**ZONING AND PLATTING COMMISSION SITE PLAN  
EXTENSION REVIEW SHEET**

**CASE NUMBER:** SP-2010-0052C(XT2) **ZAP COMMISSION DATE:** 7-7-2015

**PROJECT NAME:** Arbor Town Square

CITY OF AUSTIN – PLANNING AND DEVELOPMENT REVIEW DEPARTMENT  
SITE PLAN APPLICATION – MASTER COMMENT REPORT

**PHASING PLAN**

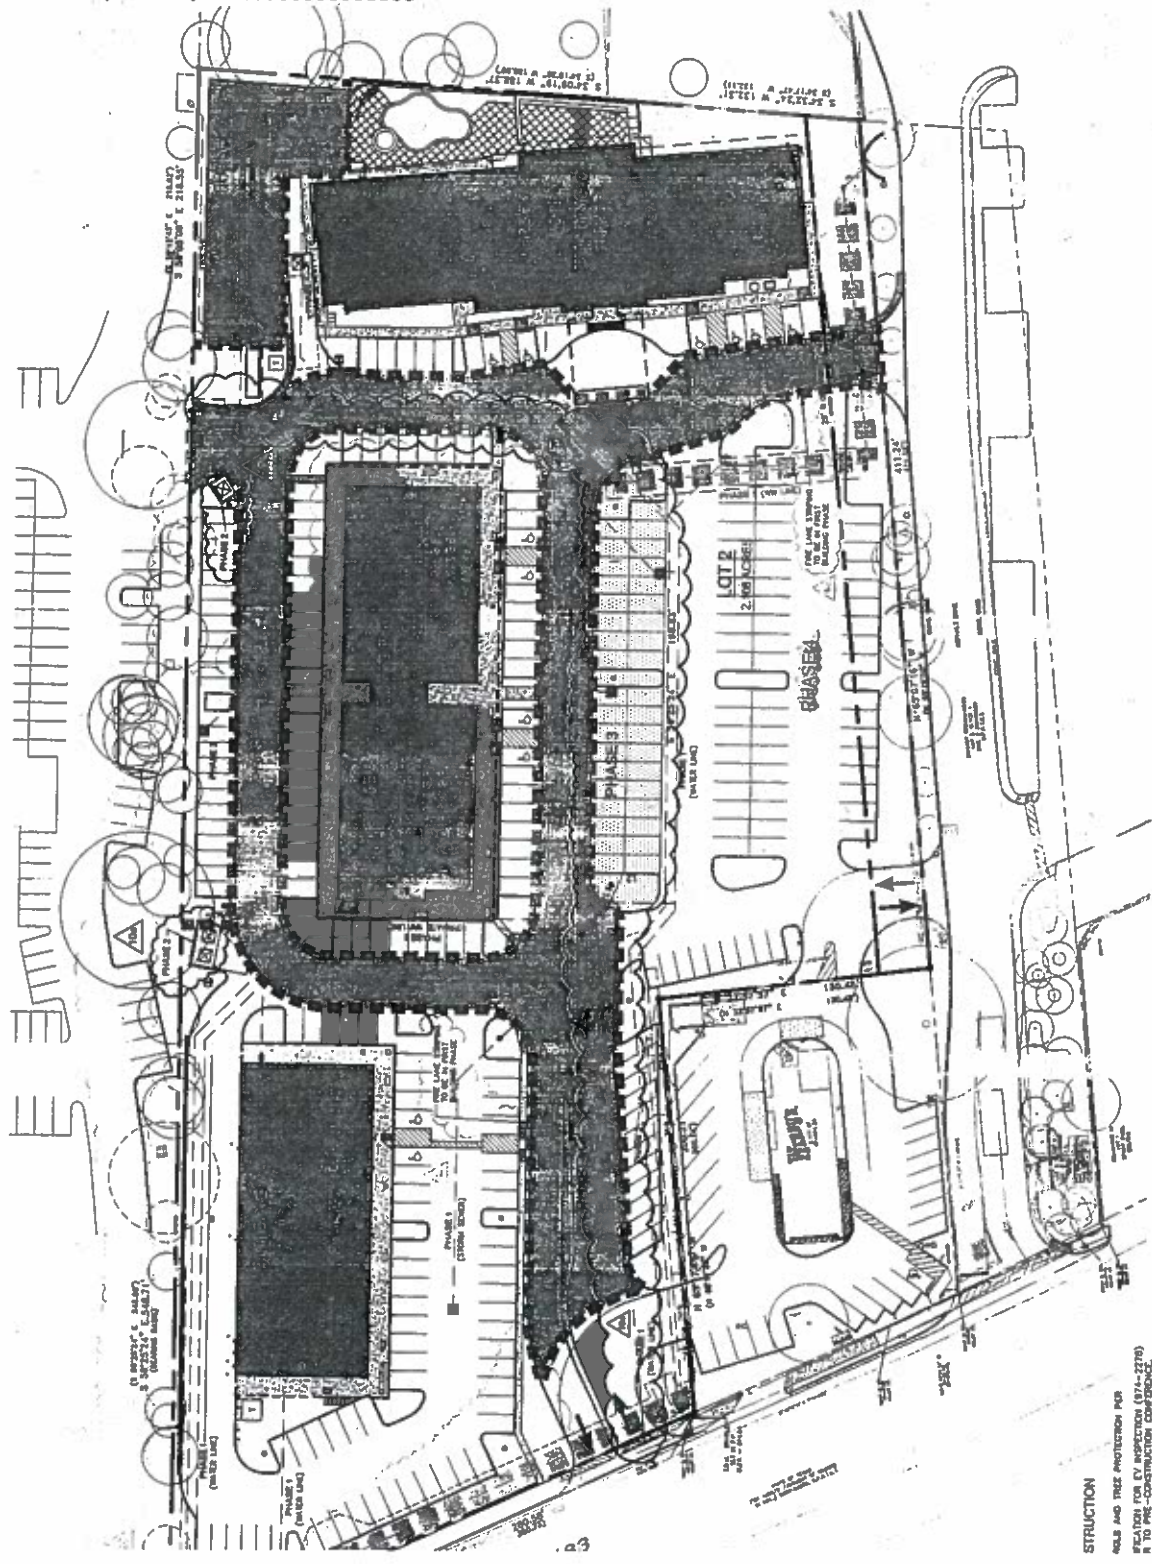
SP 3. It is not clear exactly what is built and what is remaining yet to build. Please send me an exhibit that shows what is constructed, what is left on this site plan to construct. When this goes before Zoning and Platting Commission, a clear exhibit will be invaluable to their understanding.
